Report of the Jacksonville Planning Development Department
Minor Modification Application MMA-25-32535

Address: 1715 Ionia Street, RE# 072214-0020

Request: Alteration

Recommendation: Deny

PROPOSED ELEVATIONS DATED FEBRUARY 13, 2021

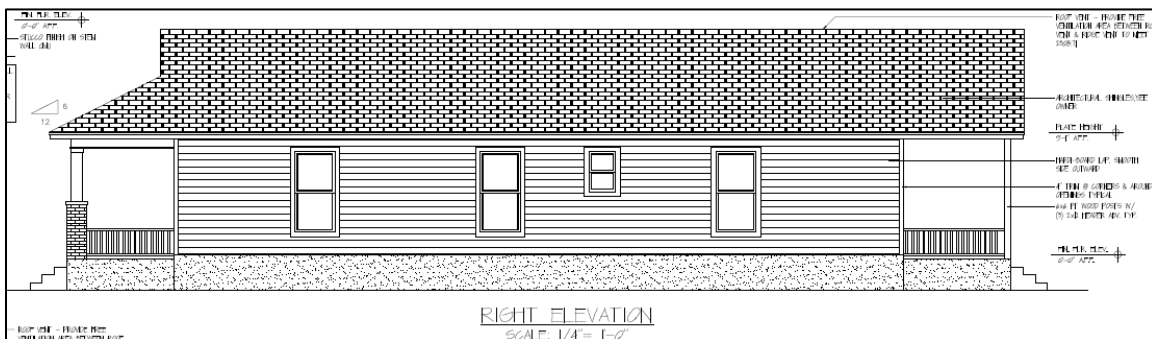
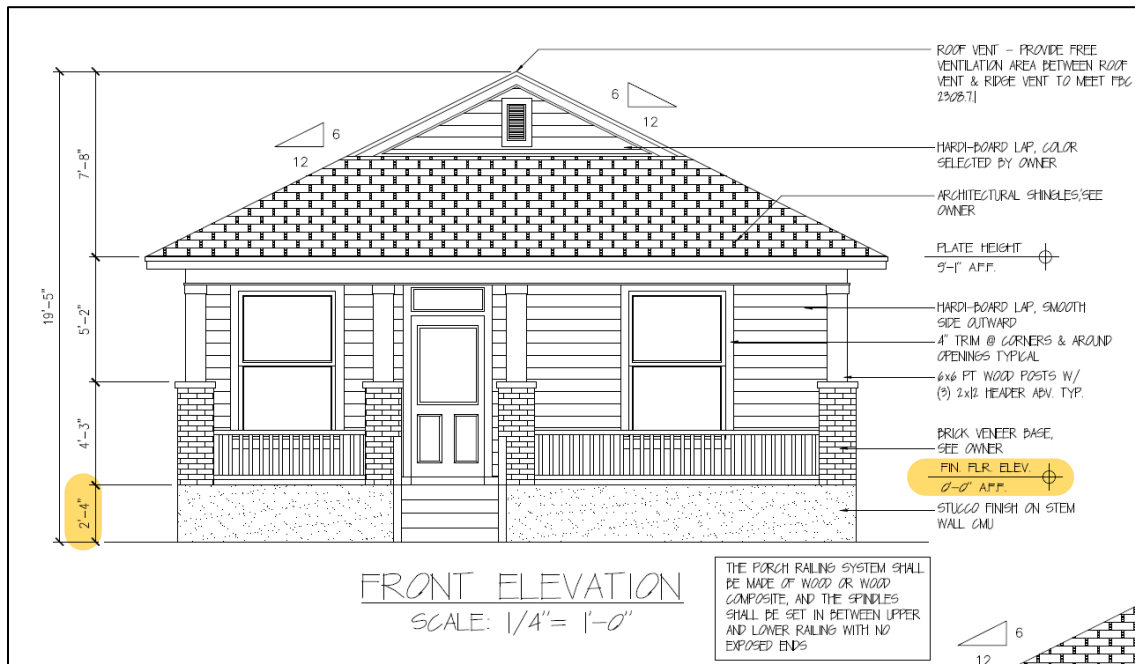
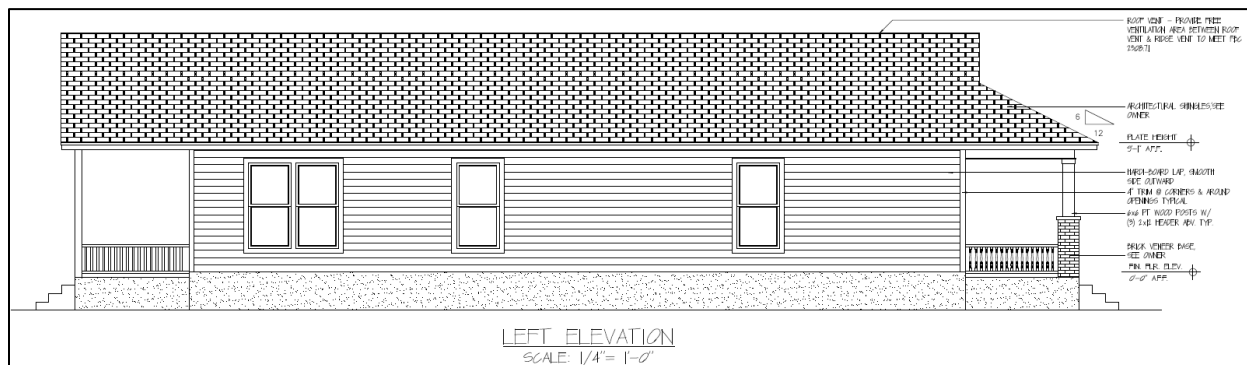
1. Decrease Finished Floor Elevation (FFE) from two (2) feet and four (4) inches to six (6) inches. (JHPC)
2. Adding a wooden board trim around the windows rather than recessing them into the structure. (JHPC)

- Standard Three refers to how each property is a product of its own time. According to the section “Foundations and Infill” of the Design Guidelines, “Nearly all historic buildings in Springfield have raised masonry foundations...[and] there are also numerous examples of concrete foundations.” The applicant’s scope of work would remove a character-defining foundation from the proposed single-family residence that is designed to be perceived as a modern frame vernacular styled structure. Additionally, the Design Guidelines state, “In some instances, particularly on Bungalows, foundation elements can be an important part of the overall design of the façade.” Decreasing the finished floor elevation and foundation height from two (2) feet and four (4) inches to six (6) inches would diminish one of the main features of this new construction within the Historic District. The proposed work is inconsistent with the Design Guidelines and Sections 307.106(k)(1-3) and 307.106(m)(1 & 6).

- Standard Nine emphasizes how new work shall be compatible with the surrounding environment. The scope of work to add wood trim around the windows to appear recessed, rather than recessing the windows according to the approved conditions that were under COA-24-30222, would be inconsistent with the current HPS Window Supplement, the Design Guidelines, and Sections 307.106(k)(2) and 307.106(m)(2).
